Houston Lighting & Power

South Texas Project  
Units 1 and 2

Response to Request for Additional Information Regarding the South Texas Project's  
Graded Quality Assurance Program Questions

Response to NRC Questions on Graded Quality Assurance Program/PSA

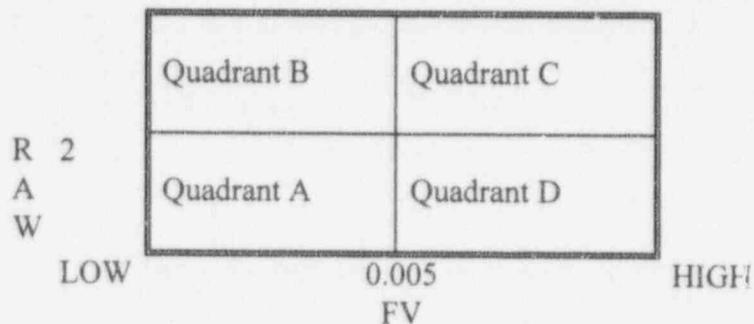
- f) *The use of the risk reduction worth (RRW) as a screening criteria makes more sense if the base-line calculations are done using failure probabilities for the SSCs assuming that all SSCs are subject to the lowest level of QA control. Since the current failure probability includes the benefit of the uniformly high QA controls, simply calculating RRW from the nominal baseline does not appear to be a robust approach; an SSC could have a low RRW using this measure, but the importance could increase considerably if QA requirements on the SSC were relaxed. Although STP defines and calculates RRW, it does not appear to be used in the categorization process. Does STP plan to use RRW measures and if so how?*

Though the Risk Reduction Worth does provide important information, it is not one of the two risk indices used in the PSA Risk Ranking Procedure. The two indices used by the risk ranking procedure will be the Risk Achievement Worth (RAW) and Fussell-Vesely Importance (FV) measures. The RAW provides an indication of the CDF or LERF given failure or unavailability of the component (e.g., out-of-service for maintenance). The FV importance measure as calculated by the RISKMAN<sup>®</sup> is the ratio of the difference in the CDF with the component failed and with the component successful over the average CDF. It is more of a reliability indicator, whereas, RAW is an indicator of configuration risk. The intent is to optimize reliability and availability to the greatest extent practical. It is important to note that the extent to which improvements in reliability or availability can be effected varies significantly from component to component and is dependent upon many factors. By maximizing the reliability and availability of components, a direct benefit in safety levels can be realized. Therefore, these two indices, used in conjunction, provide a reasonable and dependable risk ranking criteria. The following figure provides a description on how these indices are used in the risk ranking process:

- Quadrant A: Components with low FV and low RAW are components that have very little impact on the plant when they fail (i.e., when they have poor reliability) or whenever they are unavailable; thus these represent "low" ranked components and will be recommended to the Working Group/Expert Panel as candidates for "basic" graded QA requirements. Focusing efforts to improve the reliability and/or availability of these components has little pay back in terms of plant safety levels. Programs such as the Basic QA program and the Maintenance Rule provide adequate monitoring and corrective actions.

- Quadrant D: Although these components have a relatively high impact on overall plant risk due to reliability considerations (i.e., high failure rates), the impact of the unavailability of the component has a very little additional impact on plant risk; thus, these components represent a "medium" risk and will be recommended to the Working Group/Expert Panel as candidates for Basic graded QA program. The Basic program (safety-related) with augmentation or the Targeted program (non safety-related) is appropriate for this group because elements of the full program (and in some cases almost all elements of the full QA program) can be applied to improve reliability, whereas, due to their low level of impact relative to configuration risk, less emphasis on improving availability factors is required or possible to provide safety benefits.
